Permit Application Review Report
Date: 4/22/2026

Project Name: Newmark Homes Single Family Home

Project PAN: P-26-019

Project Purpose: construction of a single-family home

Figure 2: Soils and Erosion Control

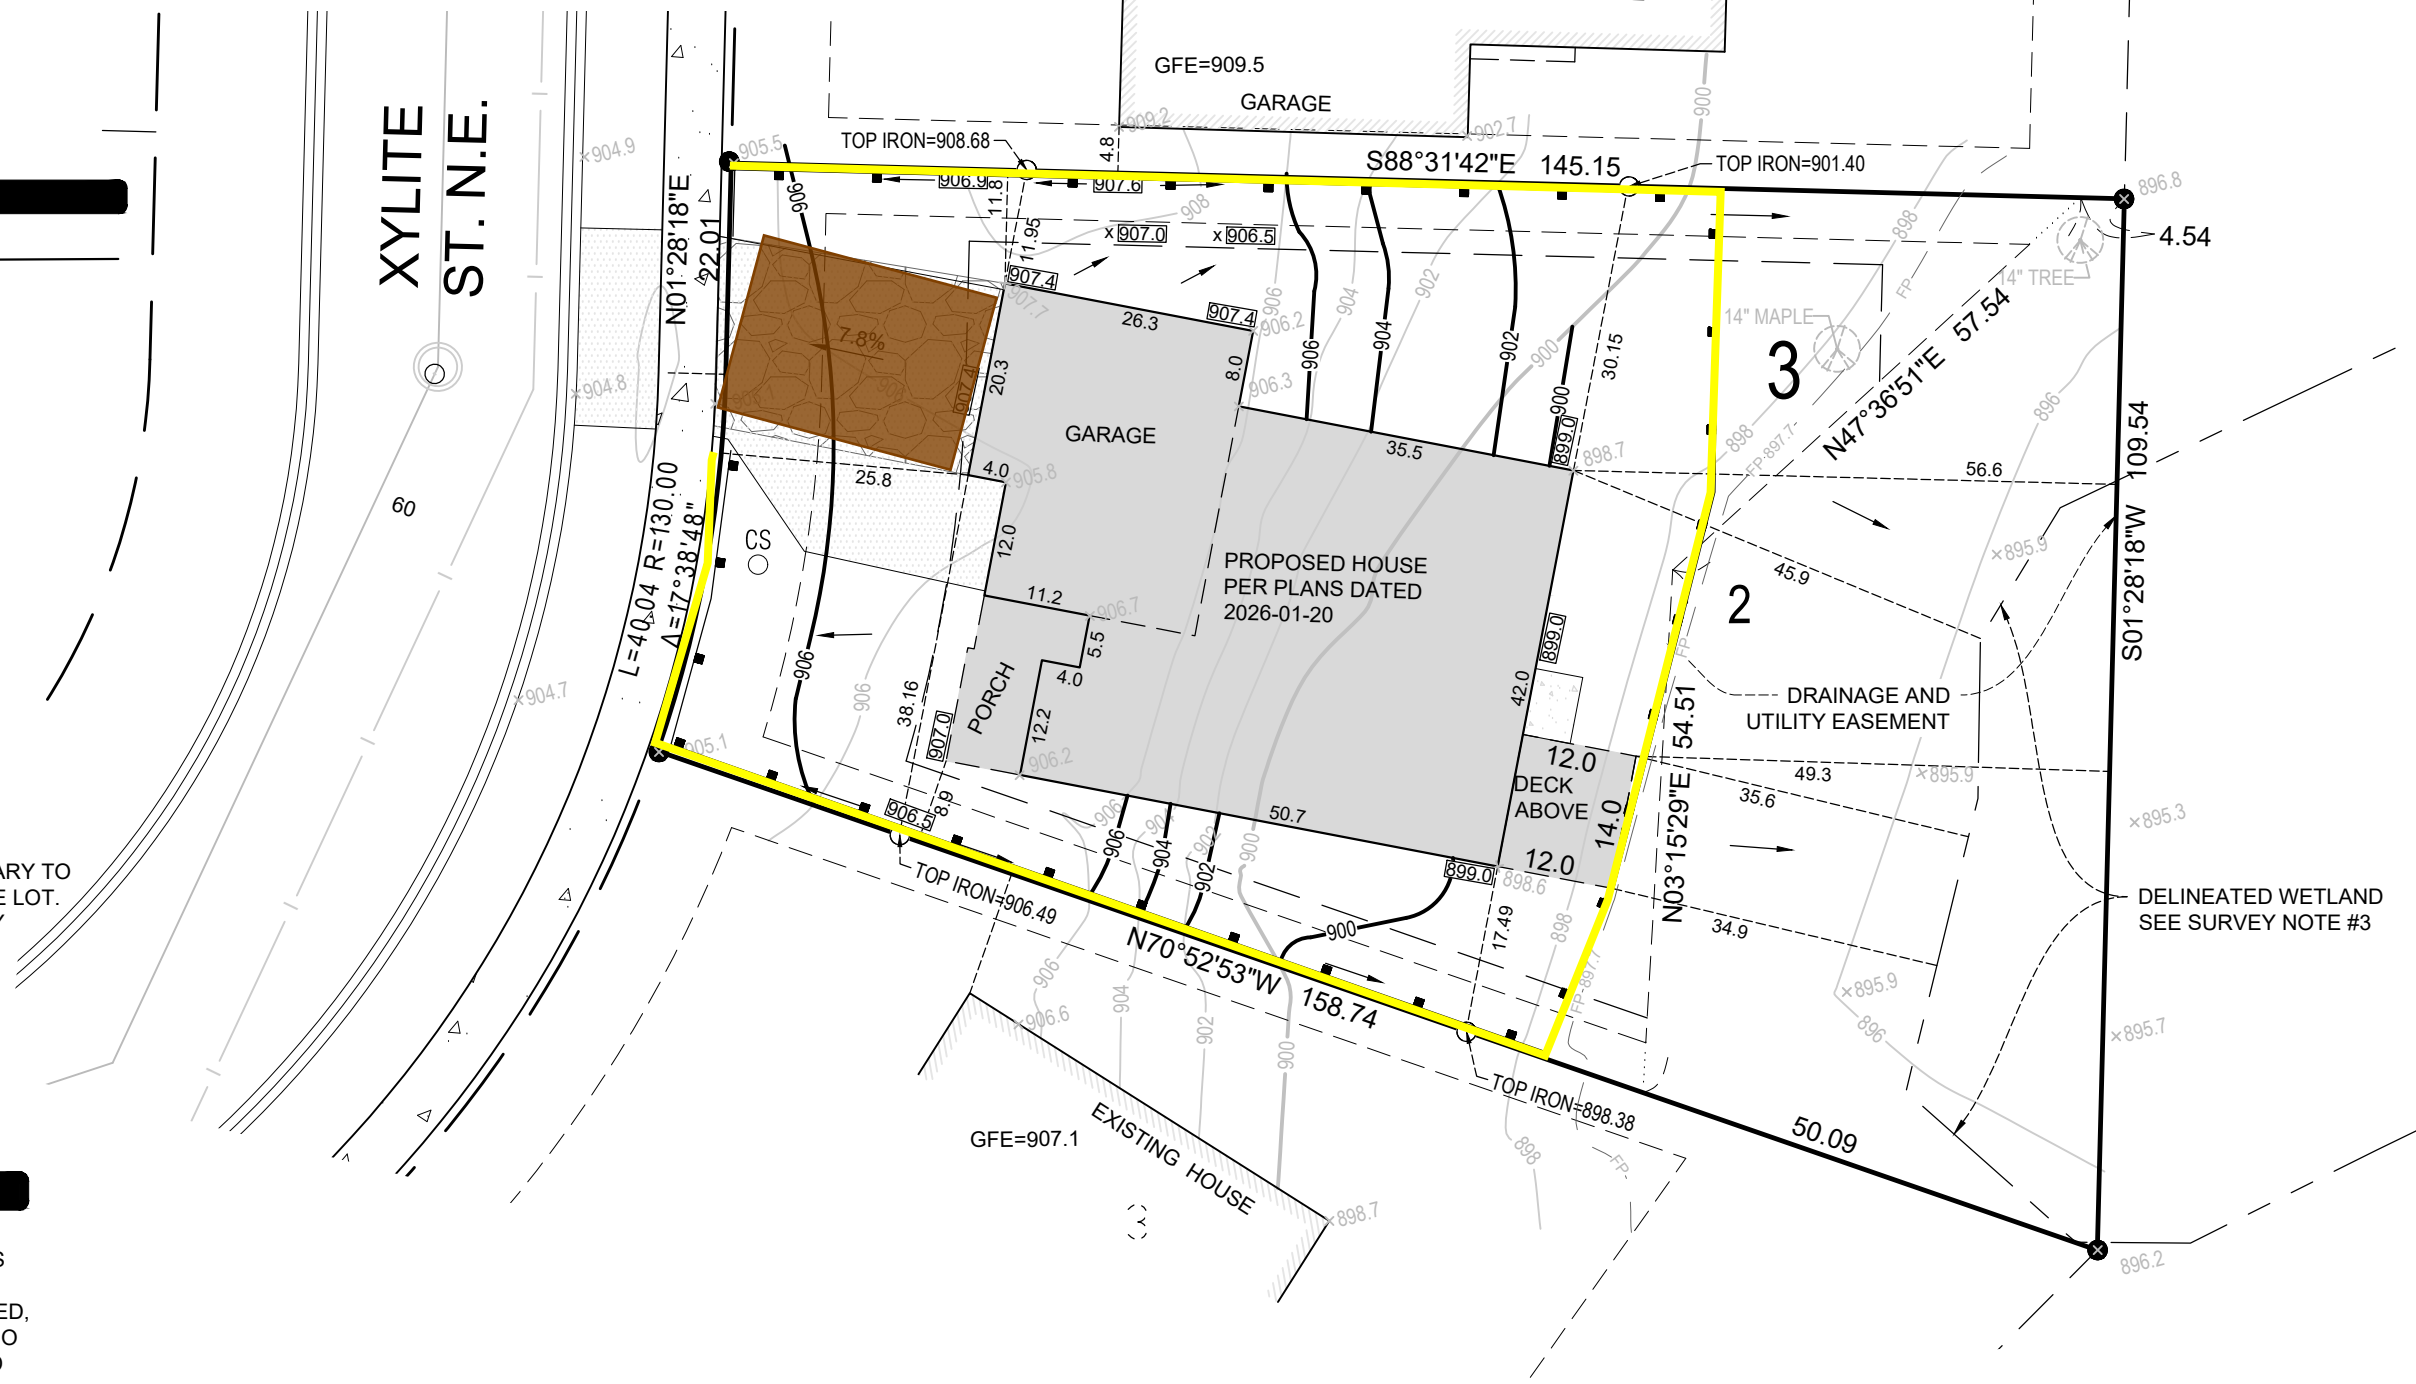
1. Update the ESC plan to include the following:
 - a. a note to stabilize soils and soil stockpiles within 24 hours if inactivity.
 - b. a note to sweep streets free of sediment by the end of each workday.
 - c. a note that inspections and maintenance of erosion and sediment control devices will take place.
 - d. provide inlet protection at nearby catch basin.
 - e. provide standard details for erosion and sediment control devices.
 - f. include a note that construction debris and stormwater contaminants will be secured and stored under cover.

The proposed project drains to Ditch 59. The soils affected by the project include Markey and Isanti and have a soil erodibility factor of 0.15 or greater. Disturbed areas are not proposed to be stabilized within 24 hours, as required. The proposed erosion and sediment control plan includes perimeter control and stabilized construction entrance. The erosion control plan does not meet District requirements because soils and soil stockpiles are not proposed to be stabilized within 24 hours of inactivity, streets are not proposed to be swept by the end of each workday, inlet protection is not proposed, provisions for the inspection and maintenance of BMPs has not been proposed, and standard details for erosion and sediment control devices have not been provided. The site does not require an NPDES permit. See attached Figure 2: Soils and Erosion Control Plan.
